## ECCC Eureka HAWS Regulatory Project - Planned site activities for the Landfarm project this fiscal year (8BC-EUR2131)

On Fri, Nov 24, 2023 at 12:20 PM Cloutier-Dussault, Jean-Philippe (ECCC) <Jean-Philippe.Cloutier-Dussault@ec.gc.ca> wrote:

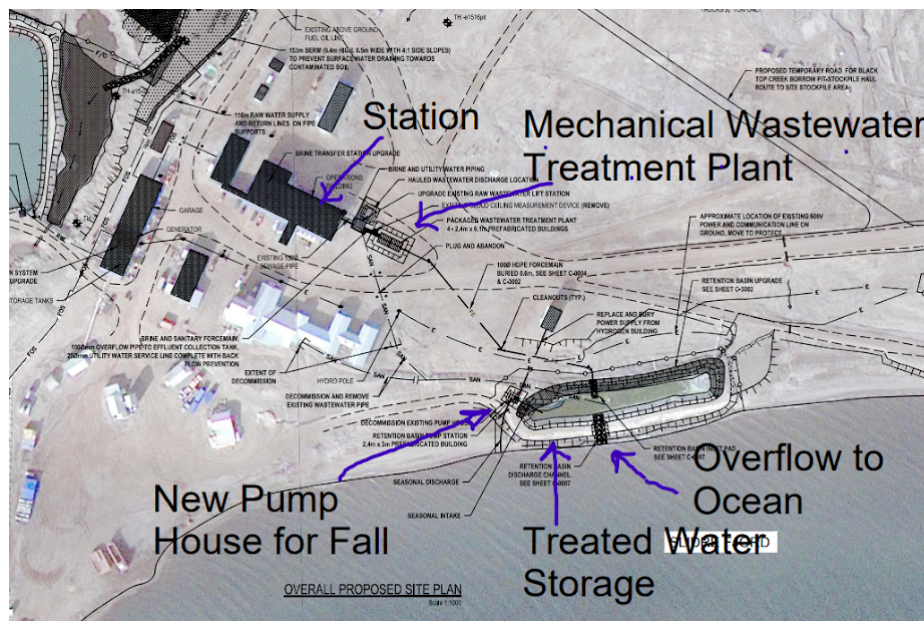
**6. From my understanding, upon completion of the new Wastewater Treatment Plant (WWTP) the sewage lagoon will become a "Wastewater Retention Pond" for treated sewage discharge from WWTP, correct or not? If this is the case, will the Final Discharge Point be after the Wastewater Retention Pond" or ECCC planning to discharge treated sewage directly from WWTP as well?**

Correct. Treated sewage or effluent from the new wastewater treatment plant will be piped to the retention pond, which is then discharged into the Slidre Fjord (i.e., the final discharge point is from the retention pond into the Slidre Fjord). When discharging from the retention pond into the ocean, two methods will be applied:

- In the summer: Retention pond will be discharge via an open channel roughly 10 metres long between the retention pond and the ocean. This is effectively an overflow channel.
- In the Fall: Retention pond is discharged using a 25 metre long, 75 mm diameter hose and pump which runs from the retention pond pumphouse to the ocean
